ADVISORY BOARD ON RADIATION AND WORKER HEALTH

**REVIEW OF THE CARBORUNDUM SPECIAL EXPOSURE
COHORT (SEC) PETITION-00223 AND THE NIOSH SEC
PETITION EVALUATION REPORT**

Contract Number 211-2014-58081
SC&A-TR-SEC-2016-0001, Revision 1

Figure A-1. Lognormal Distribution of Uranium Data, Using Regression on Order Statistics (ROS)

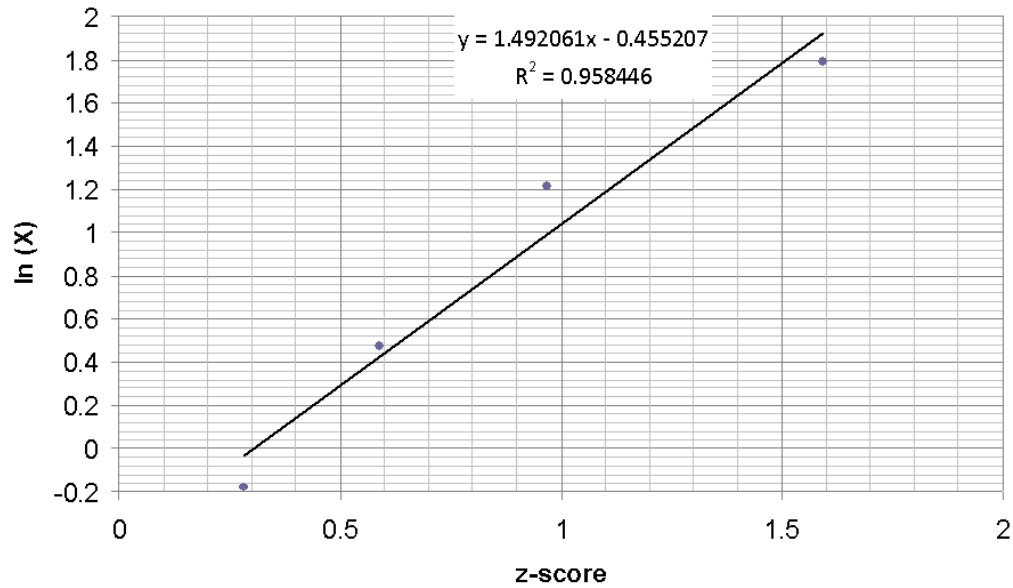
The ER reports that “a statistical analysis of [the uranium] samples results in a GM of 1.666 dpm/m³, a GSD of 2.5111, and a 95th percentile of 7.578 dpm/m³.” We disagree with NIOSH’s statistical methods, which are discussed in greater detail in section 5.2 of this review. Our results for the uranium air samples lead to slightly lower air concentrations than the NIOSH values. We likewise disagree with NIOSH’s statistical analysis of the plutonium dust samples. In this case, our 95th percentile airborne plutonium activity concentration is approximately 16% larger than the NIOSH value. A corresponding increase would apply to intakes during the second residual period due to residues from the second operational period.

The regression of order statistics (ROS) method was used to fit a lognormal distribution to the , including the six nondetect values. A plot of the logarithms of the data versus the normal score for each observation is shown in Figure A-1. (The figure omits the five samples for which no results are listed in the survey report.) The plot also contains a regression line which best fits the plotted data points. The slope and intercept of the regression line are also shown on the figure.

Figure A-2. Lognormal Distribution of Plutonium Data, Using Regression on Order Statistics (ROS)

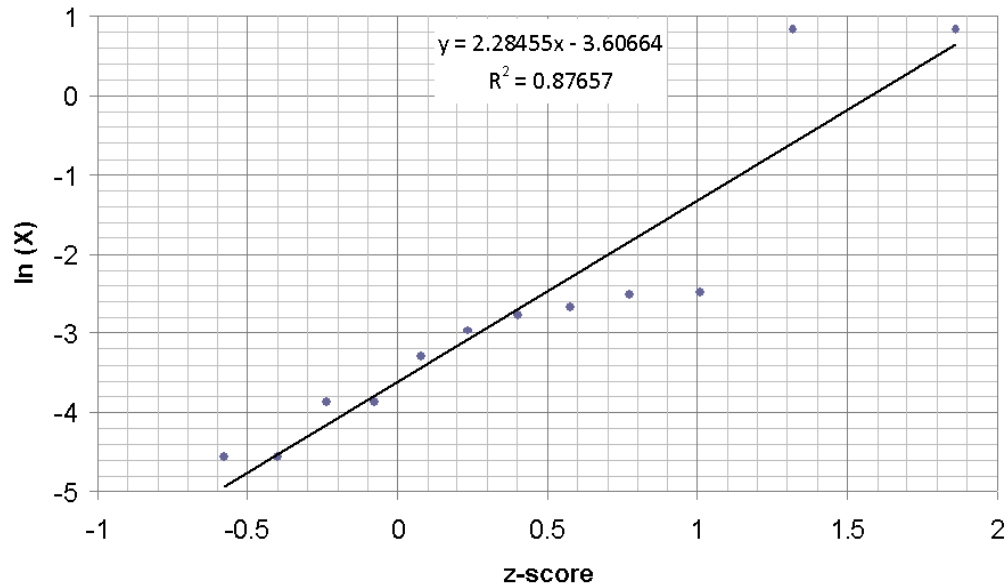
0.0271 dpm/m³, a GSD of 9.821, and a 95th percentile of 1.164 dpm/m³, as compared to the NIOSH values of 0.026 dpm/m³, 9.288, and 1.005 dpm/m³. The 95th percentile obtained by the ROS method is approximately 16% larger than the NIOSH value: The intake by operators is estimated to be 7.651 dpm per calendar day vs. 6.606 calculated by NIOSH. We recommend that NIOSH adopt that ROS value, which is consistent with NIOSH procedures as prescribed by OTIB-19, does not rely on questionable assumptions, and is claimant favorable. The intakes by workers in other job categories, as well as ingestion intakes, should be adjusted accordingly.

Figure A-2 shows a plot of the plutonium sampling data. The value of $R^2 = .8766$ indicates a good fit to the regression line for the lognormal distribution. (The figure omits four nondetect data points included in the distribution.) The characteristics of this distribution are shown in Table 2.
